Comments for Planning Application 19/00707/FULM

Application Number: 19/00707/FULM

Proposal: Residential Development of 175 Dwellings including Formation of Vehicular Access, Access Roads, Open Space, Landscaping, SUDS and Associated Infrastructure

**Westfield Development, Forfar
Planning Application 19/00707/FULM
Transportation Assessment**

Diagram 19304/1 – 20-year Accident record (Source: Crashmap.co.uk, details should be confirmed with official record)

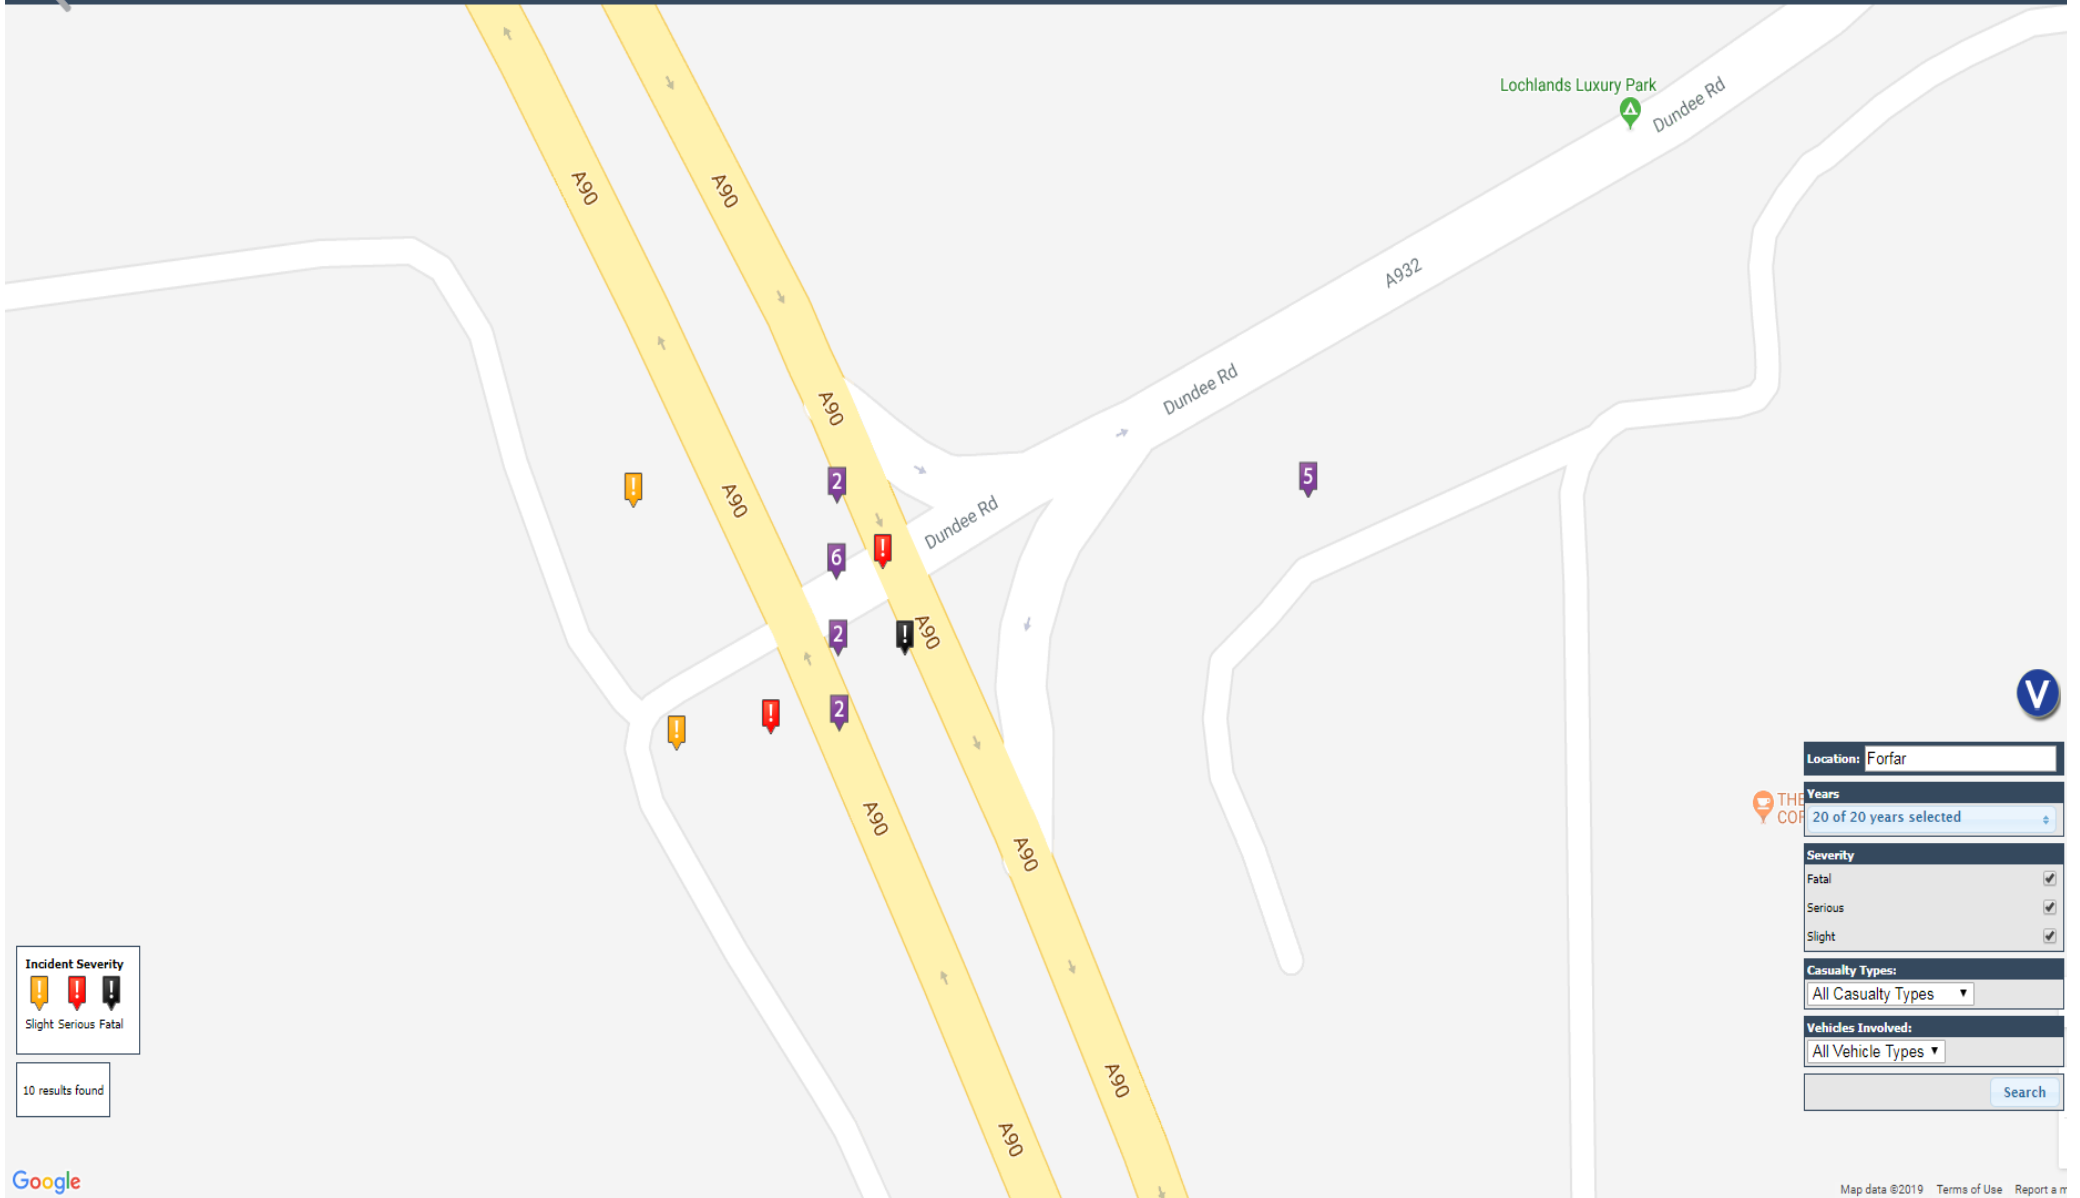
- 2) the safety of proposed site access junctions, which are designed as priority cross-roads, but provided with visibility standards for much higher speeds that are not consistent with Designing Streets policy;
- 3) the TA junction analysis should be updated to represent a practicable build date for residential development on this scale that is consistent with the Local Development Plan;
- 4) the TA must be update to representatively model the impact of Westfield development traffic on the A90 / A926 signalised cross-roads; and
- 5) the TA must address the obvious road safety implications of increased queuing at the A90 / A932 trunk road priority junction, given its continuing safety issues.

In our assessment, these matters require to be addressed, and the Transportation Assessment updated accordingly, before any planning permission is granted. Also, appropriate mitigation measures and accessibility improvements should be attached as conditions to any planning consent granted.

Image 4, A90(T)/A932 Lochlands Junction, accidents 1999-2021
(source: CrashMap.co.uk)

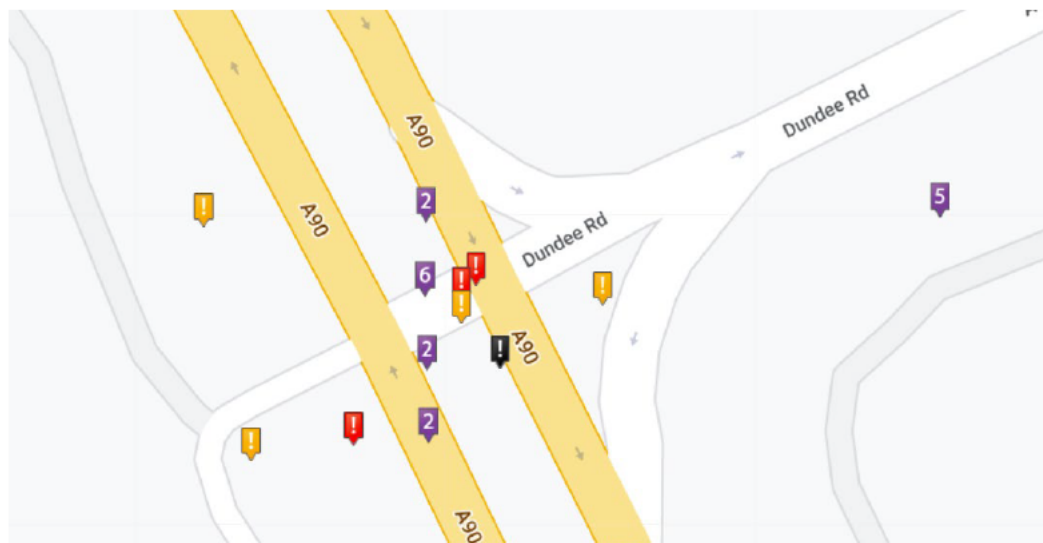
- c. The Lochlands trunk road junction is the site of some 25 injury accidents over a 23-year period, including 1 Fatal; 10 Serious and 13 Slight (Image 4, below). **As a result, there is an obligation on the Roads Authorities to ensure that the impact of the Westfield development on the junction is**

mitigated, and that Westfield development traffic does not cause a detrimental impact on the capacity and safety (due to increased queuing).

Figure 7 and Table 23 have been reproduced below for reference.

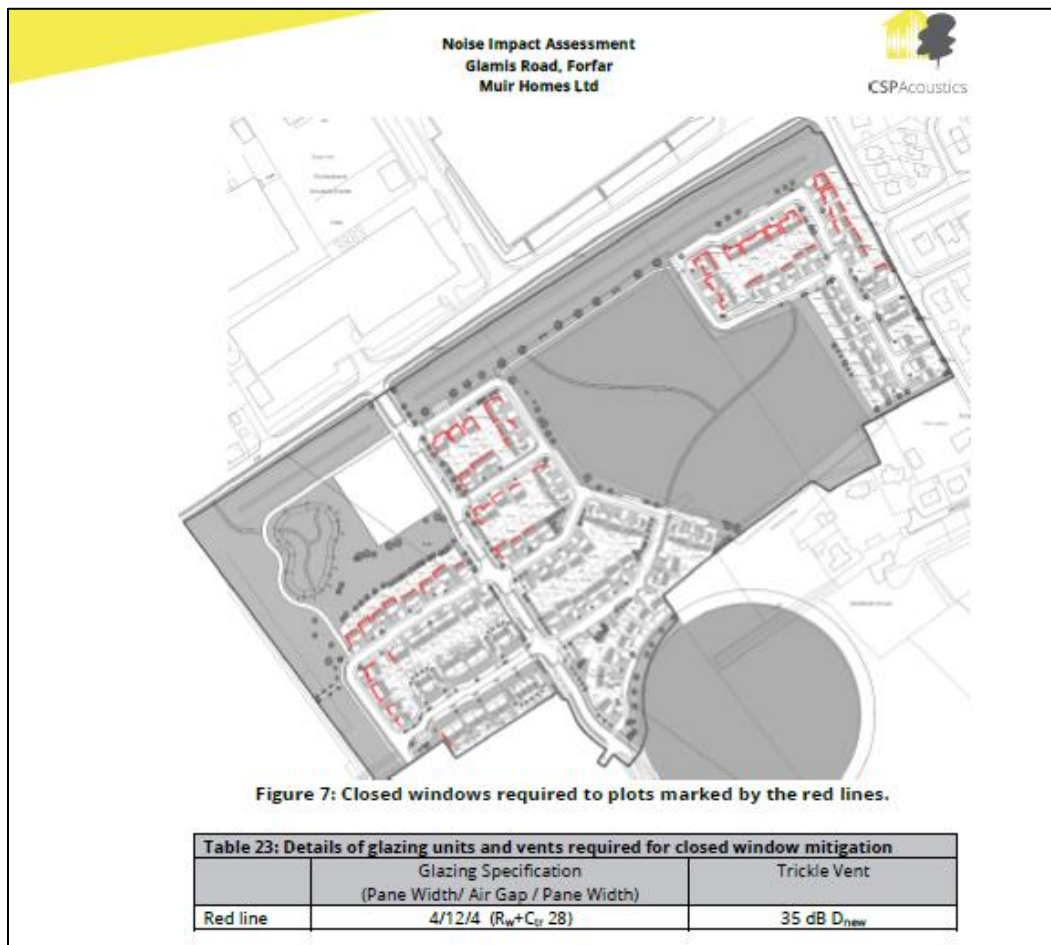
Para 9.07 provides a table of glazing recommendations for the various locations on site, with a plot of specific locations where opening a window is not recommended.

As can be seen the proposal is for closed windows primarily for the northern elevation of the site.

Diagram 22123/3 – Illustration of Walking Distance from proposed development to Bus Stops

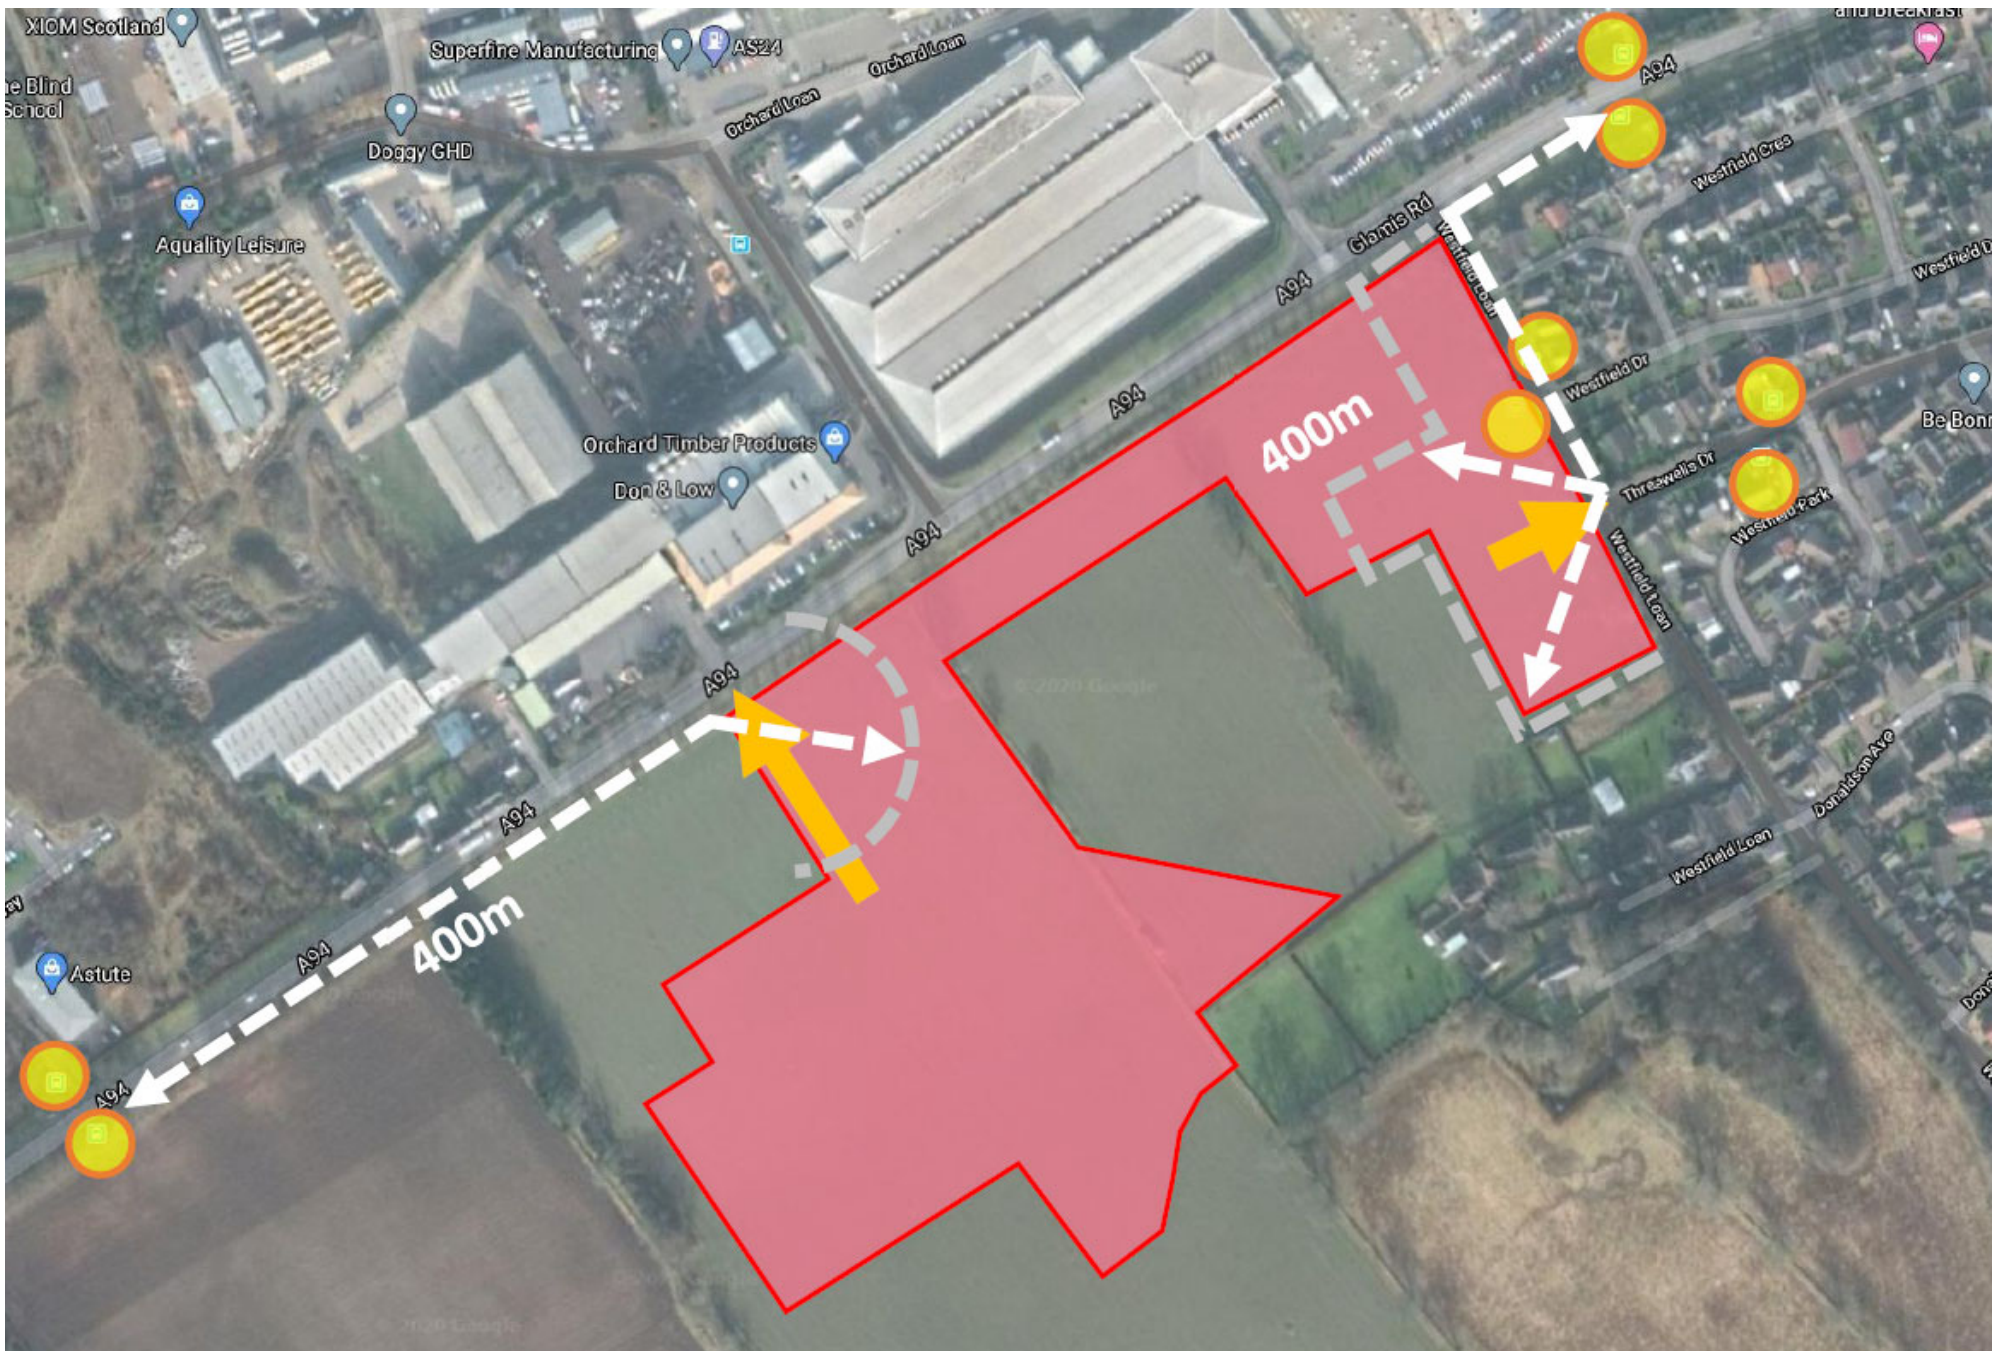
8. (3.6) The TA states that *"The site is therefore located within walking distance of existing public transport services and these can be reached using existing and planned foot and cycle links."* This is demonstrably not the case, as this assessment demonstrates that only 18% of units within the proposed development (Phase 1) would be within 400m walking distance of existing bus stops, and no new bus stops or services are proposed.

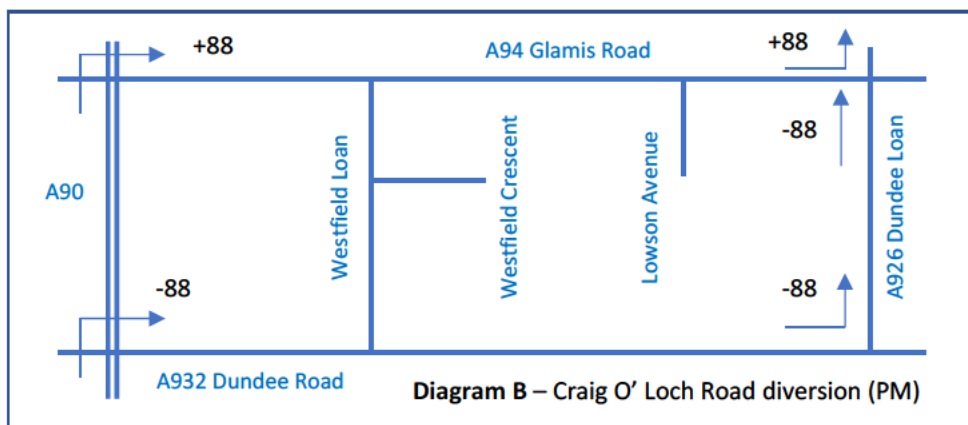
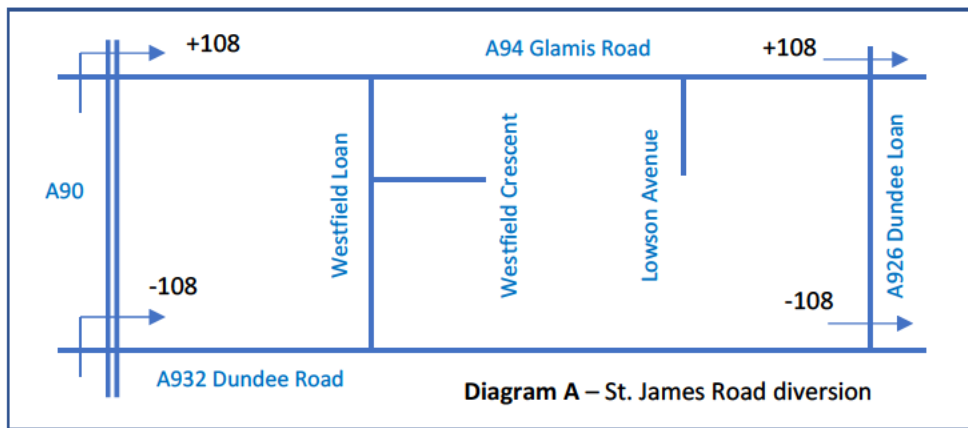
13. (WPA 1.16) Tracking of potentially diverted traffic - The supplemental West Port Analysis document considers the potential diversion of some existing traffic as a result of a closure of the central reservation at the A90 Lochlands junction. This has been undertaken by “detailed tracking of the right turning traffic at Lochlands”. There is no explanation given of the methodology used to track vehicles through the network. This should be provided.

14. (WPA 1.17-1.20) The assumptions made in the redistribution of right-turning traffic at Lochlands are considered reasonable, however the example given (of 317 vehicles) is unclear. The issues with the approach taken are best seen in diagrammatic form (see below), considering each diversion element separately.

15. Diagram A indicates the diversion from St. James Road, and this is accepted as shown and described in the WPA report (1.17). Diagram B shows the diversion of traffic destined for A926 Craig O’ Loch Road, and this also is accepted as described (1.18).

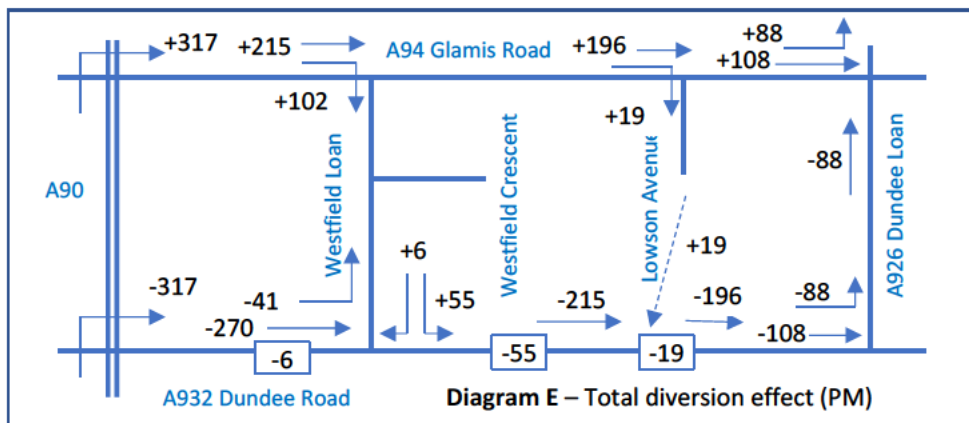
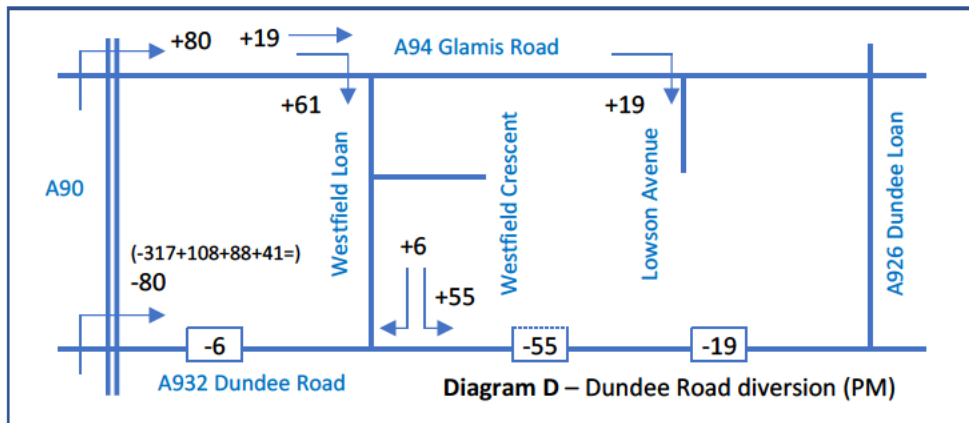
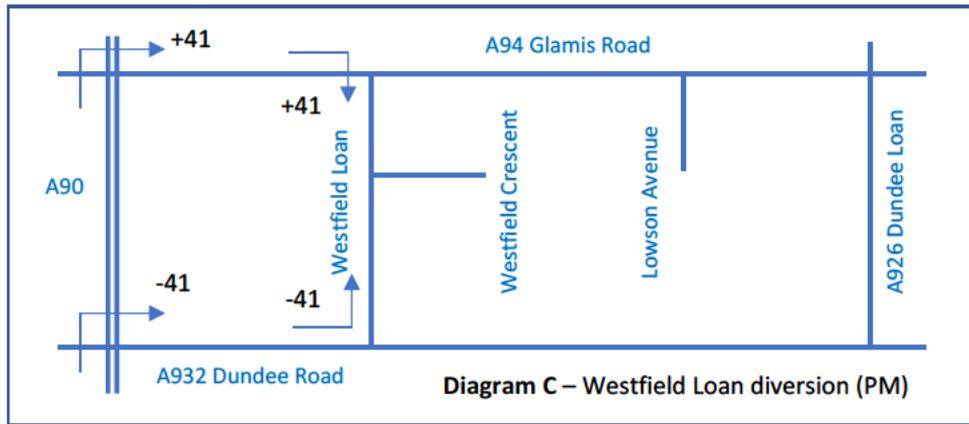
16. Diagram C, below, shows the described diversion of right-turning traffic at Lochlands that is destined for Westfield Loan.
17. The description of the treatment of this traffic (WPA 1.19) is accepted, and this is shown in diagram below, however it is not readily apparent from Diagram 4b in the WPA report that this is reflected on the diagram. However, it is the treatment of the final component of diverted traffic that causes confusion of the traffic flow diagrams, specifically Diagrams 4a and 4b, but as a result, all consequent diagrams.
18. Diagram D shows the diversion of traffic turning right (east) at Lochlands which is assumed to have a destination on Dundee Road. The information shown on the diagram below is derived directly from the description given in the WPA report,

section 1.20, however the remainder of right-turning traffic at Lochlands would be 80 vehicles (317 -108 -88 -41), whereas WPA Diagram 4a shows only 61 southbound vehicles emerging from Westfield Loan (6 turning right, 55 turning left), and no traffic travelling south to re-join Dundee Road via Lawson Avenue, as described in WPA, Section 1.20.

19. Diagram E, above, shows the actual diversion effect described in the text of the WPA (1.17 to 1.20), but this is not the diversion effect that is shown in Diagrams 4a and 4b, and therefore the traffic flow diagrams should be updated and the analysis of the relevant local road network junctions undertaken.
20. (UTA 6.19, WPA 1.24) Committed Development - As is appropriate in all traffic analysis of future design years, account is taken by the UTA of committed development traffic; traffic associated with development holding planning permission, not yet built out, but which can be built out in future without further recourse to the PPIp process.

The revised site layout is provided below for reference.

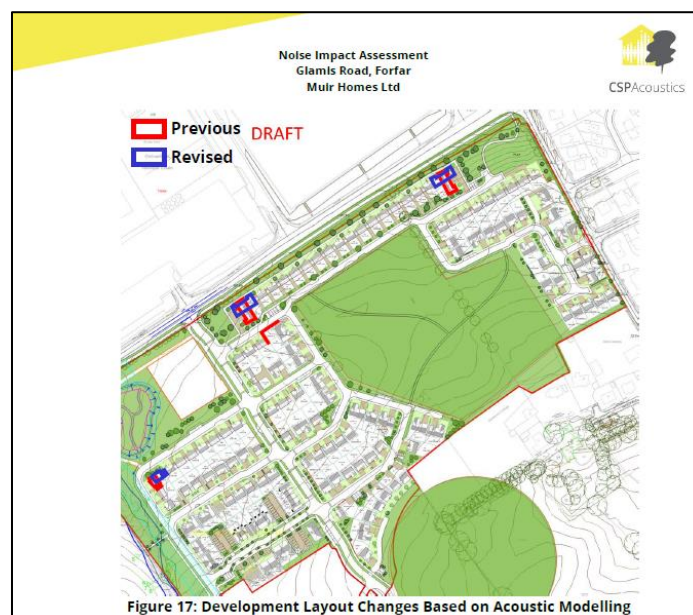
CSP Acoustics ran initial modelling and indicated that the initial proposal site layout would not provide adequate mitigation and recommended minor alterations to 5 No plots, with a 6th plot requiring a 3m high acoustic boundary fence.

A Road Traffic Noise Assessment was then completed by CSP Acoustics, which provides numeric and pictorial results for the worst-case positioned dwellings. The resulting values are then compared against trigger noise levels used within TAN to PAN 1/2011 guidance. The results appearing in Table 25: TAN to PAN1/2011 Assessment, provided below for reference, indicate that the internal noise levels inside the habitable spaces of the dwellings will be met. This is caveated with the proviso that all habitable room windows are only located on the rear of the likely exposed buildings.
